Public Service Commission

The Reclamation Division has reviewed Coteau's April 1, 2015 response to our technical review letter dated December 11, 2014 of Revision 18 to NACT-0201. The following issues must be satisfactorily addressed before we recommend Commission action.

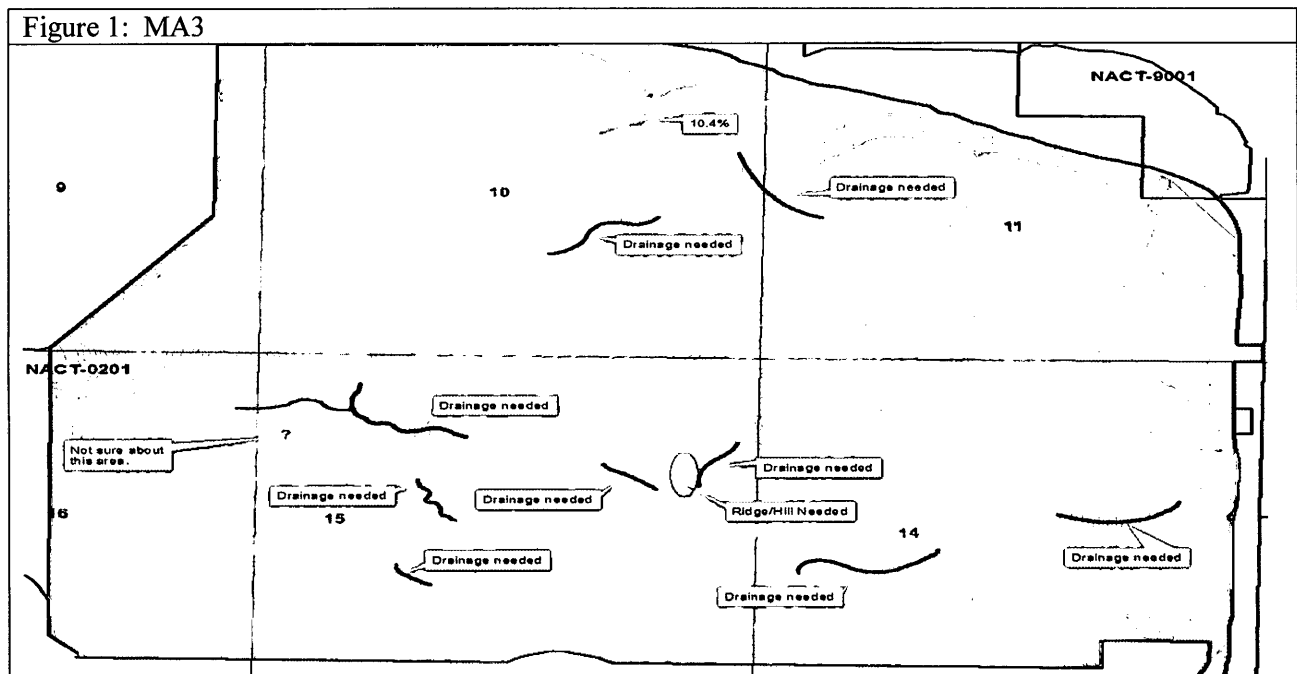
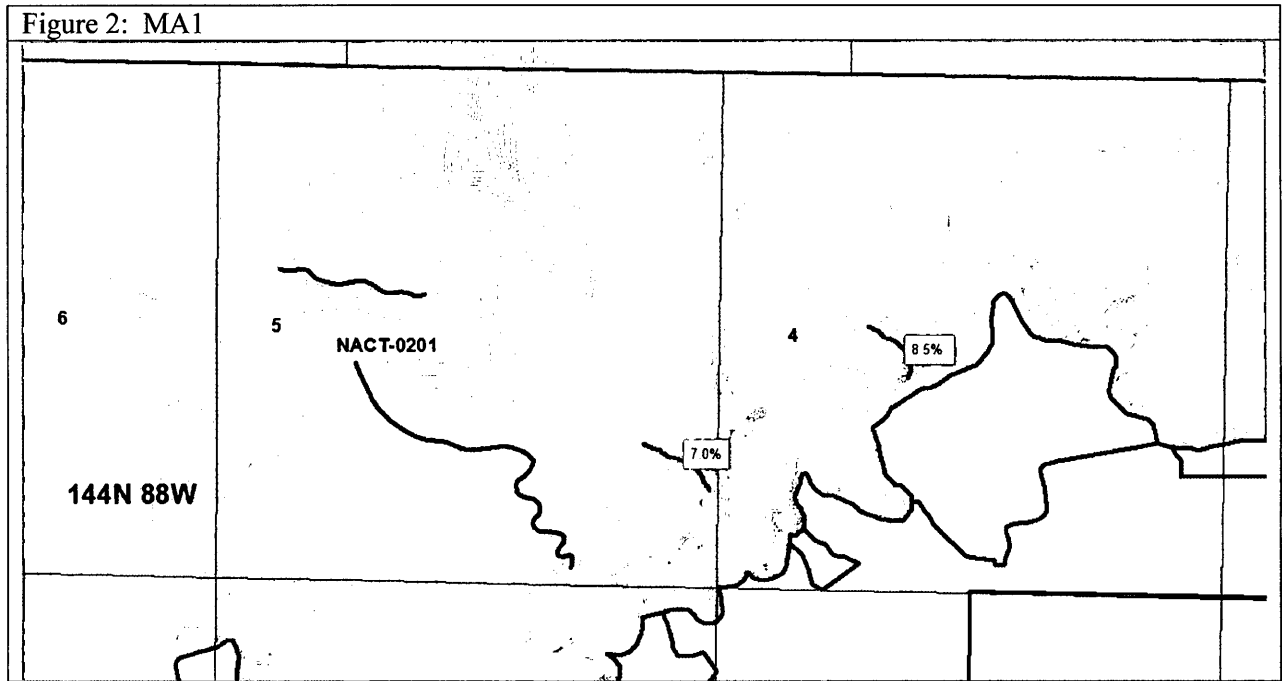
49. Follow-up to Items 112 through 115: Please consider adding secondary drainages as depicted on Figures 1 and 2 below to improve long-term stability by reducing slope length and to further minimize runoff from passing over steep slopes. Please also consider reducing slope steepness in the drainage ways shown in red on Figures 1 and 2. (GAW)

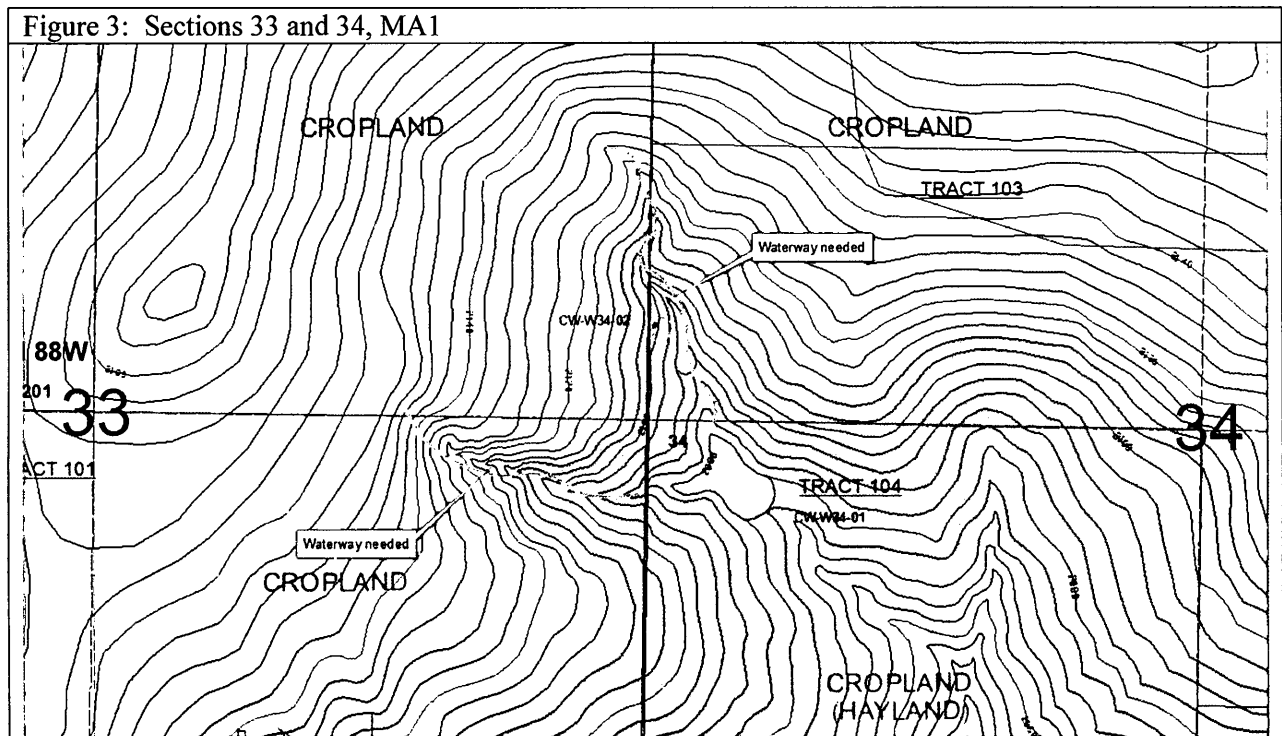
50. Follow-up to Item No. 122: Please add grassed waterways in recreated drainages on cropland in Sections 33 and 34 as depicted in Figure 3: (GAW)
